#### PLANNING COMMISSION MEETING AGENDA CITY OF WHITE BEAR LAKE, MINNESOTA

SUBJECT:	Walser Polar Chevrolet, 1801 County Road F - Case No. 19-1-CUP & 19-1-V
DATE:	February 21, 2019 for the February 25, 2019 Planning Commission Meeting
FROM:	Samantha Crosby, Planning & Zoning Coordinator
ТО:	The Planning Commission

TO:	Samantha Crosby, Associate Planner
FROM:	Connie Taillon, P.E., Environmental Specialist Dan Holzemer, Senior Engineering Technician
DATE:	February 6, 2019
SUBJECT:	Walser Polar Chevrolet Engineering Review Comments

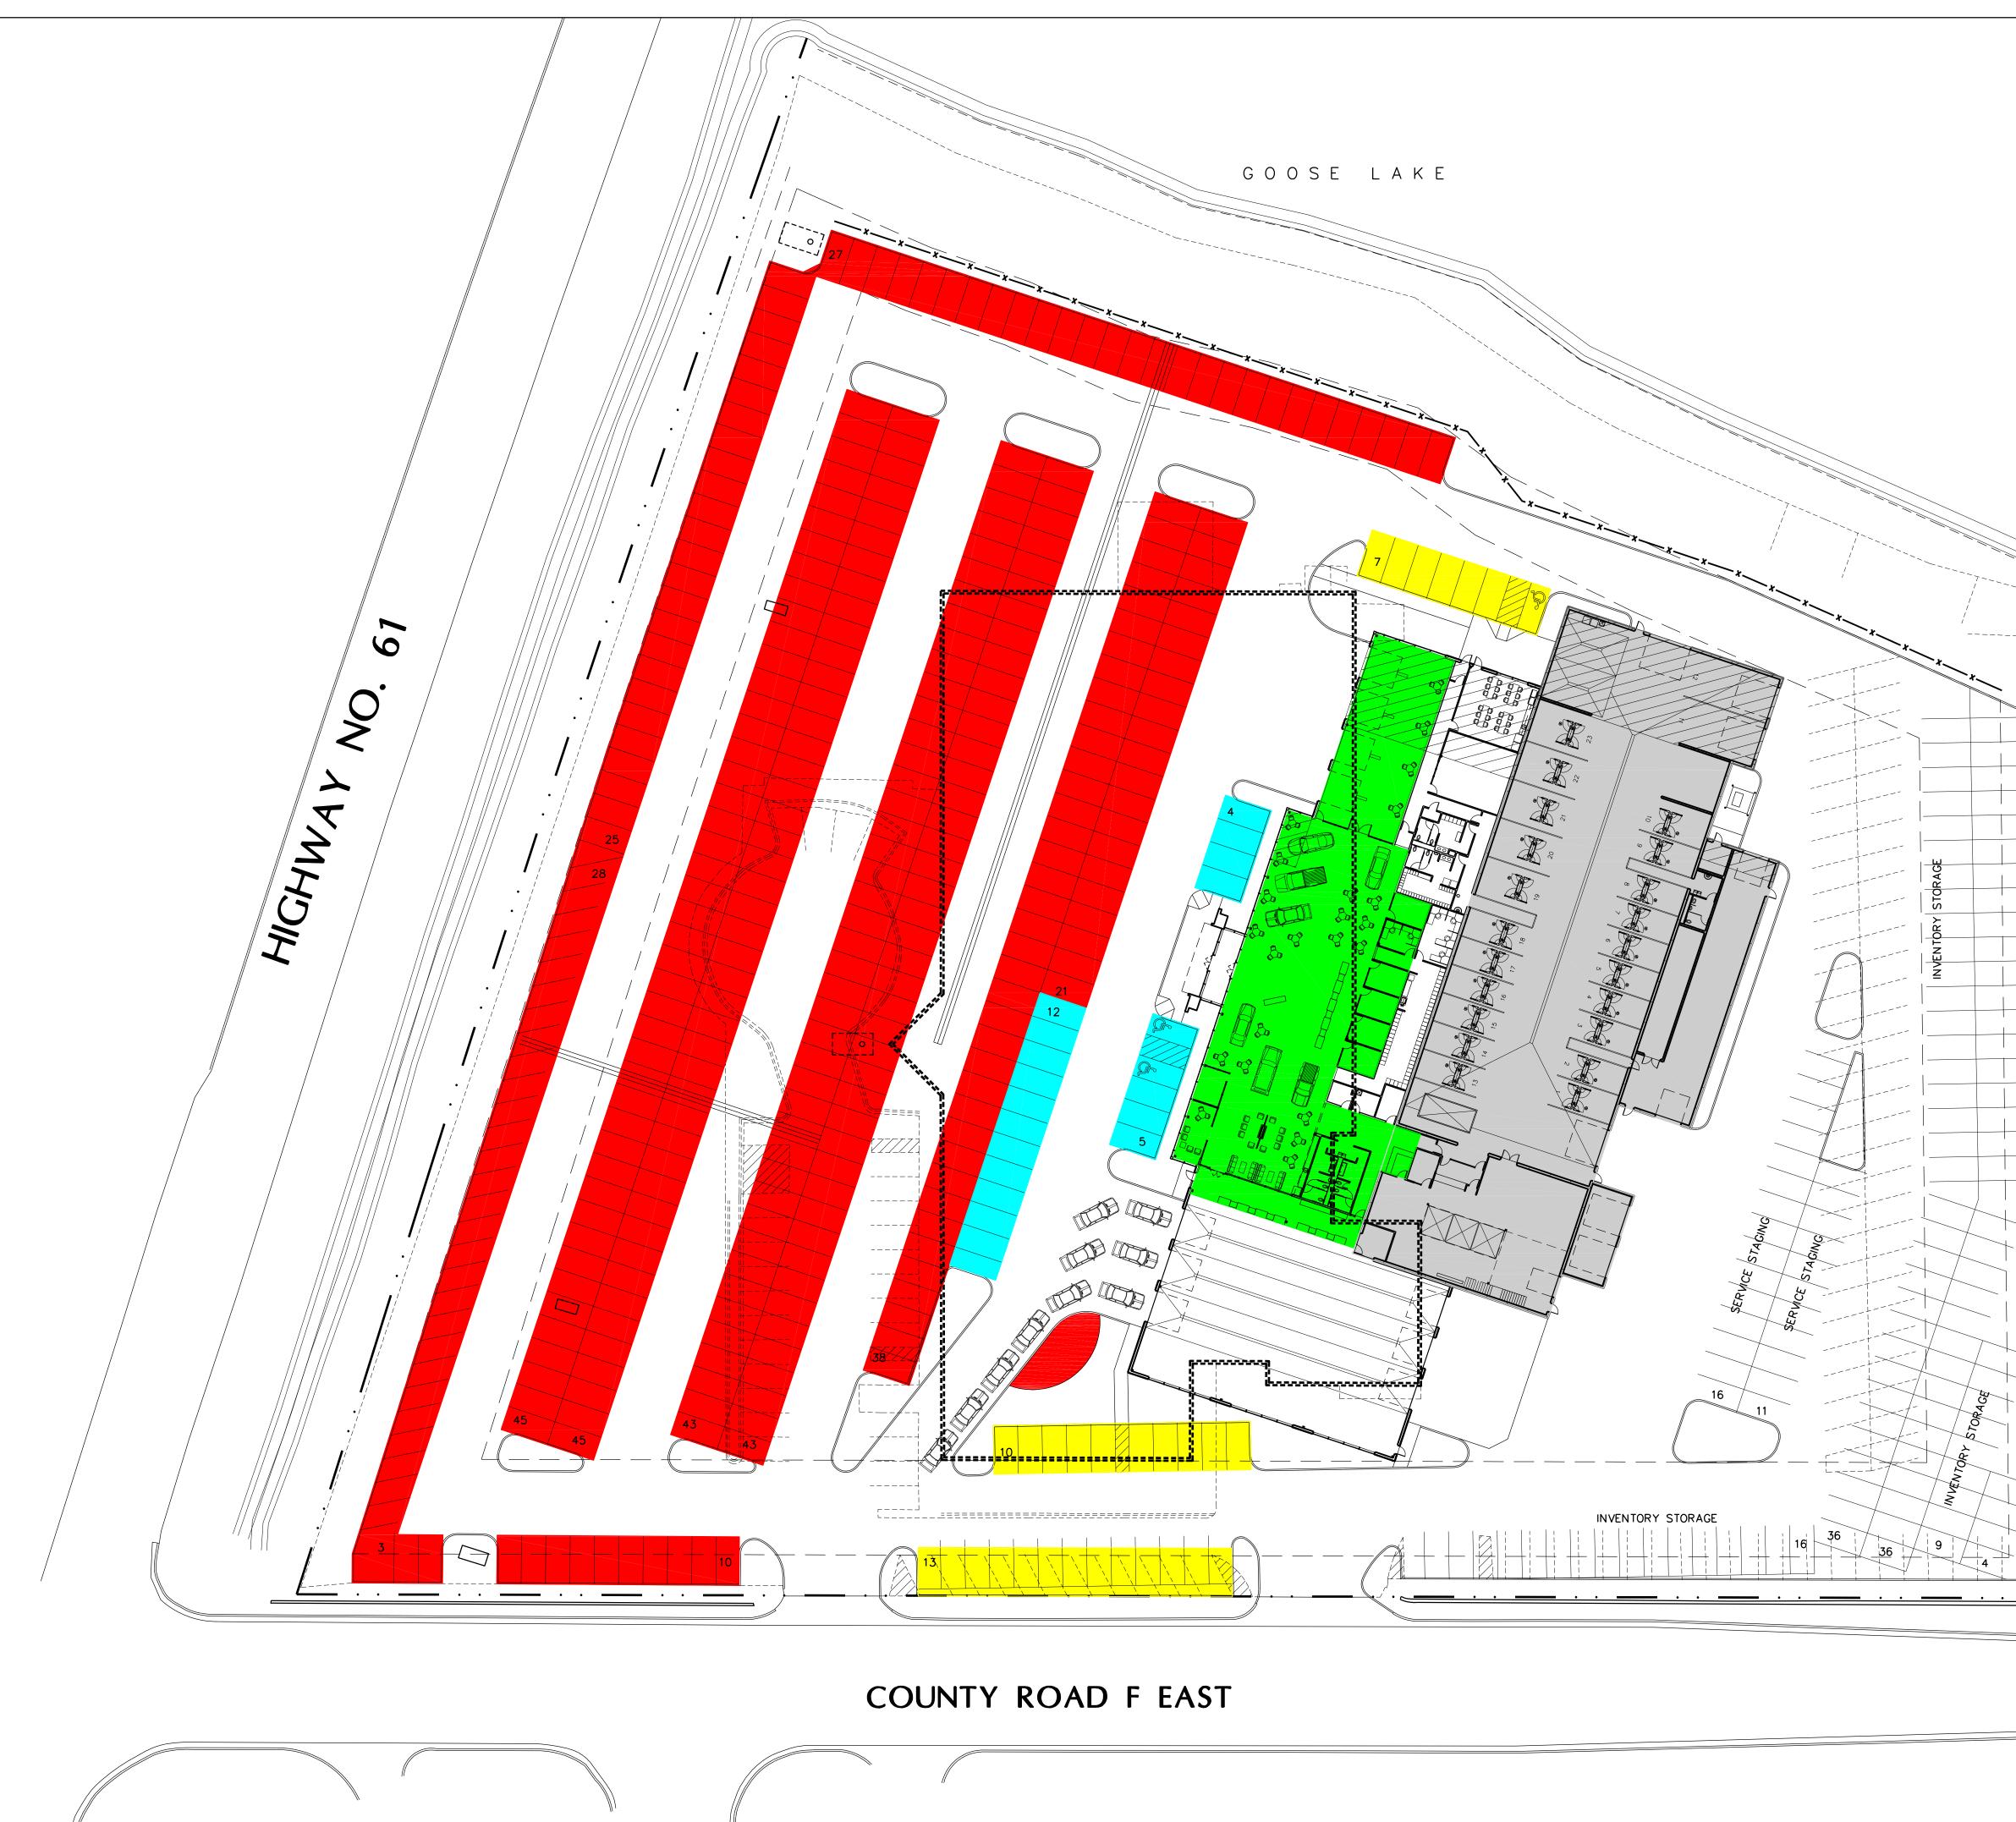
- 7) Remove the 100-year FEMA floodplain line and add the 927.8 BFE (NGVD29). Include the BFE on Sheet C-3.0 Grading, Drainage, and Erosion Control Plan and Sheet C4.0 Utility Plan.
- 8) Update the detail numbers and sheet numbers in the callouts to be consistent with the detail sheets.

CLARK WIC	KLUND, PE	
Date		License No.
QUALITY	ASSURANC	E/CONTROL
BY	DATE	
DATE	ISSUE	
1-14-19	CITY SUBMIT	TAL
PROJECT	TEAM DAT	A
DESIGNED	:	МК
DRAWN:		MLS
PROJECT	NO:	180201
C	2-3	.0

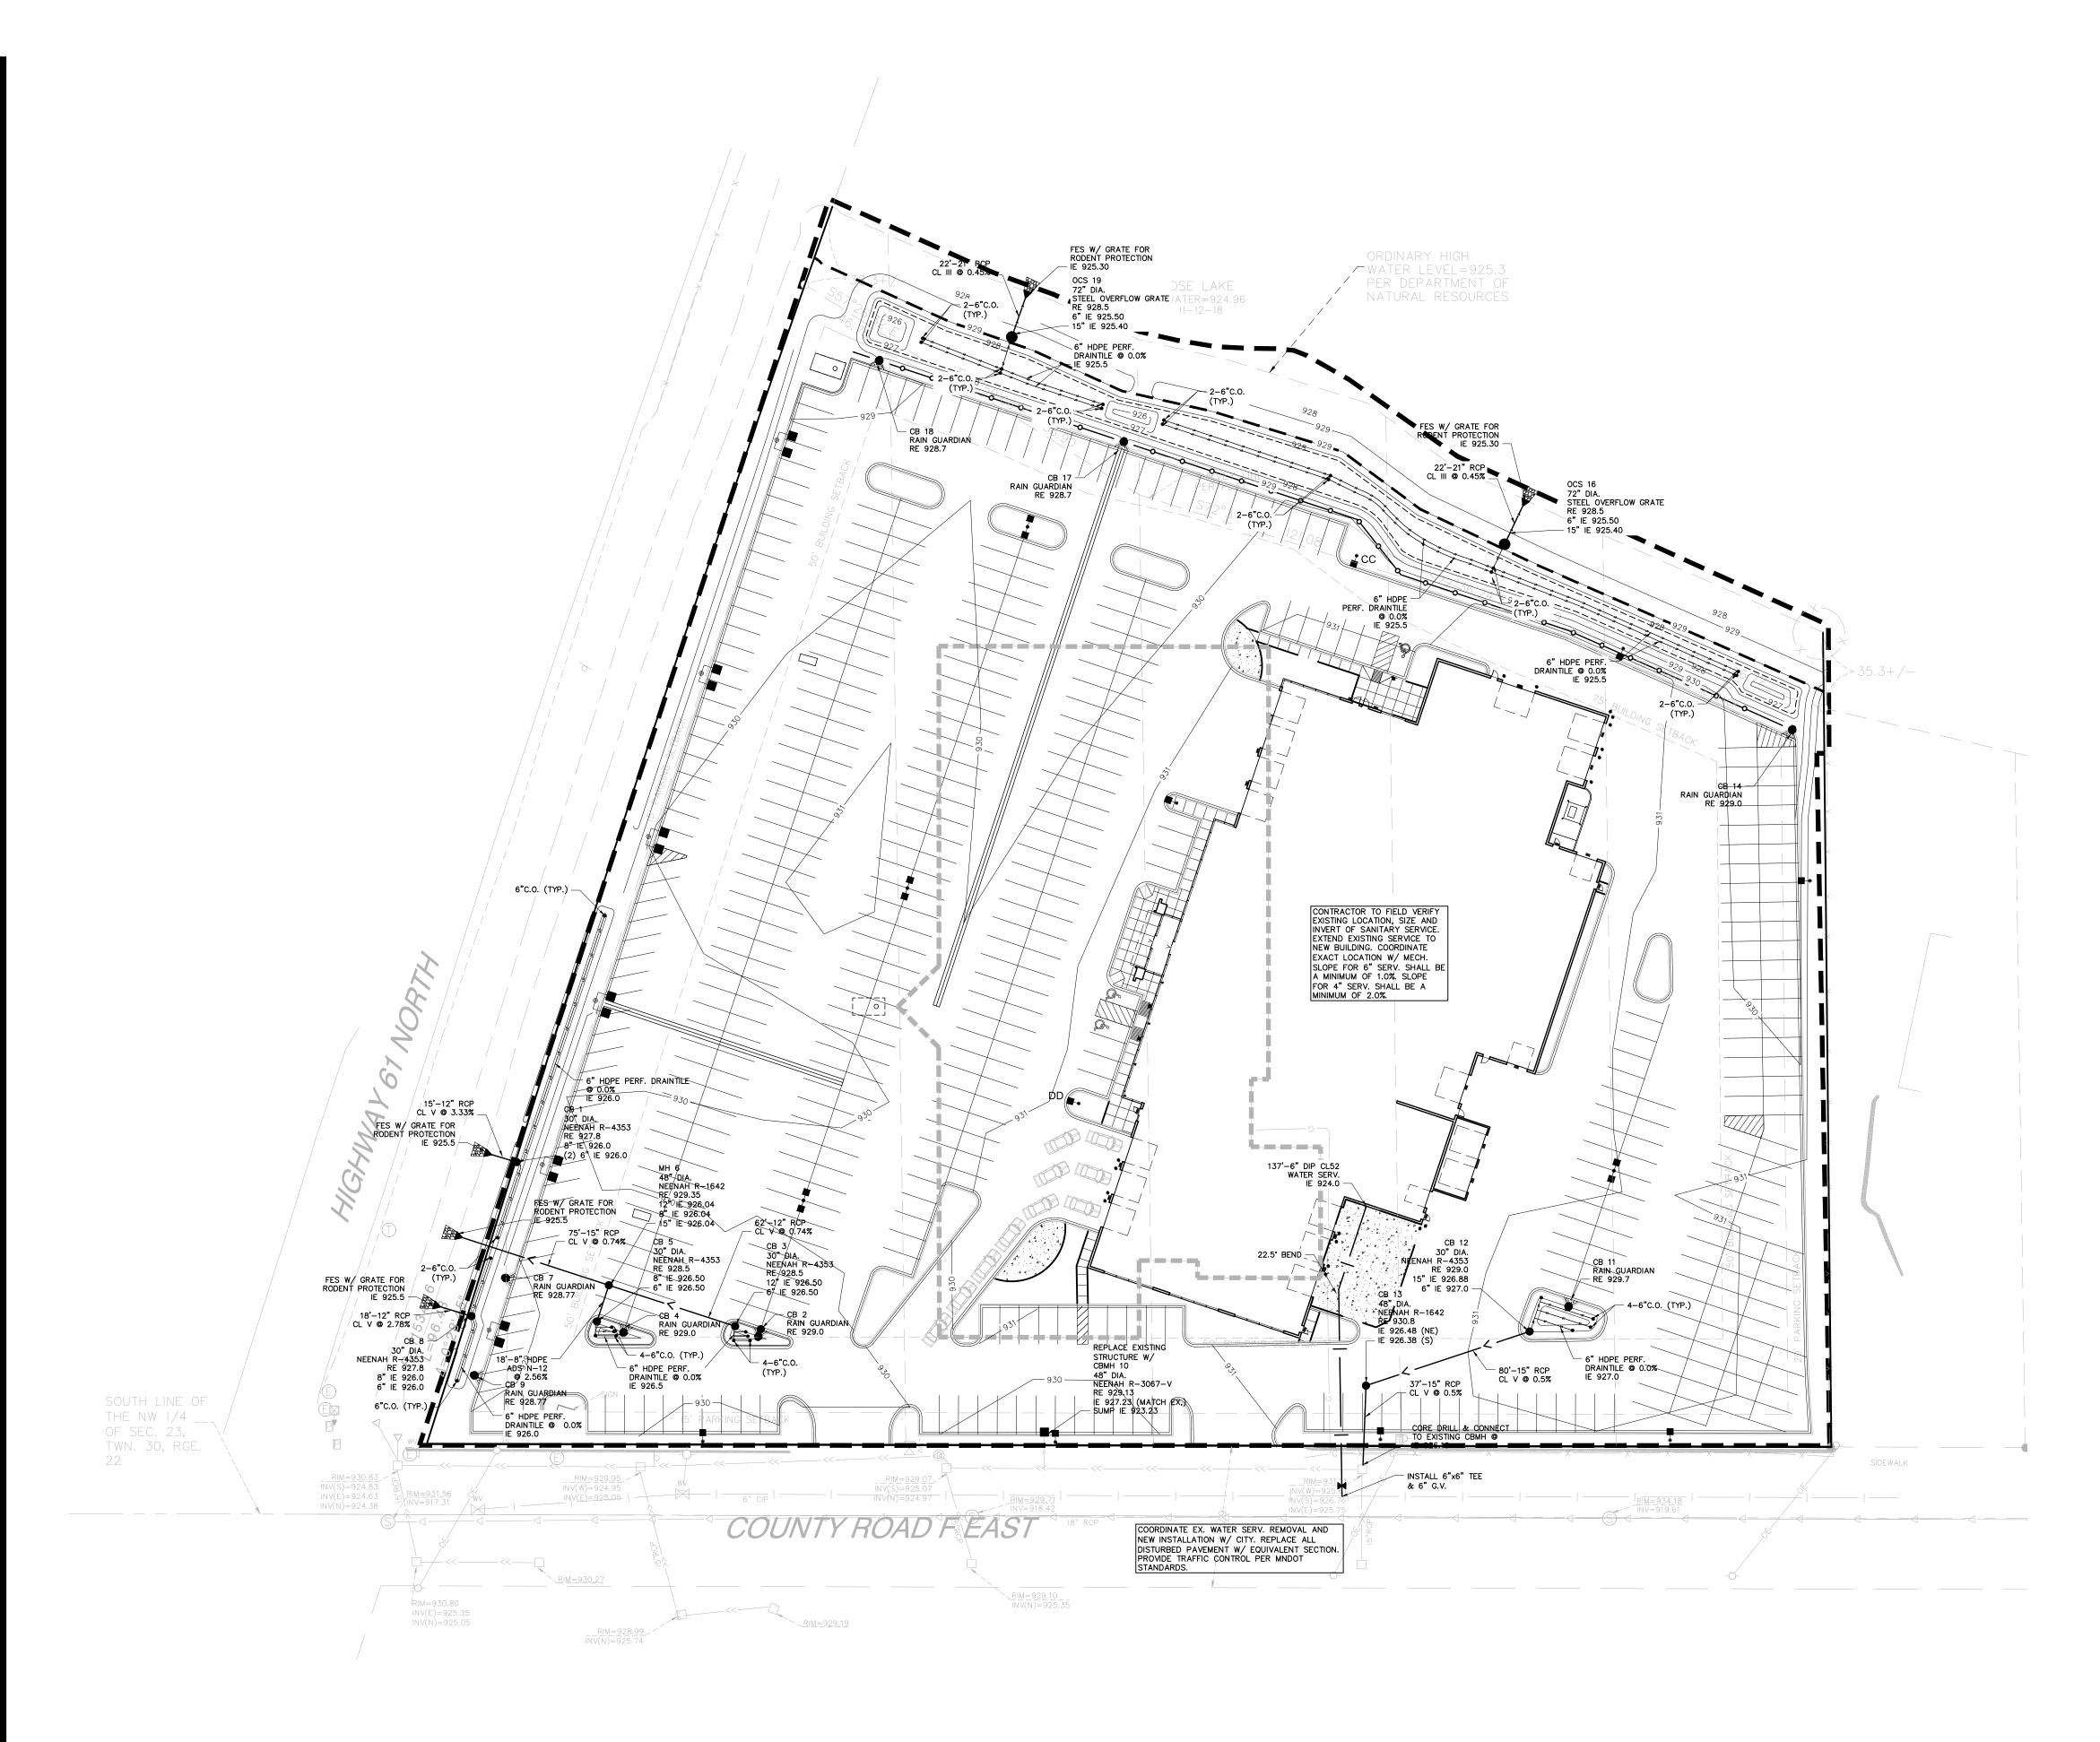
- 9) Add the following to the plan:
  - OHWL for Goose Lake
  - 927.8 BFE (remove FEMA floodplain line)
  - HWL for all stormwater basins
  - EOF location and elevation for all stormwater basins
  - Spot elevations for the filtration basin island curb gutter to ensure that the gutter directs flow into the spillway.
- 10) The top of berm elevation for the north and west stormwater basins should be a minimum of one foot above the 100-year high water elevation.
- 11) Add a rain guardian at the end of the valley gutter that flows to basin 2 on the west side of the site. Move the proposed light pole out of the flow path of the valley gutter.

- Label as "section A-A" to be consistent with the plan view label
- Drain tile and bottom of basin invert elevation
- Top of sand elevation
- Specify iron filling/sand mixture in the callout
- 13) Filtration basin section: why is compost specified in the infiltration basin?
- 14) Include a cross section of the west filtration basin (basin 2) on the plan.
- 15) For the north filtration basin, are the shallow ponding areas downstream of rain guardians pretreatment basins? How will the iron enhanced sand be kept out of these basins?
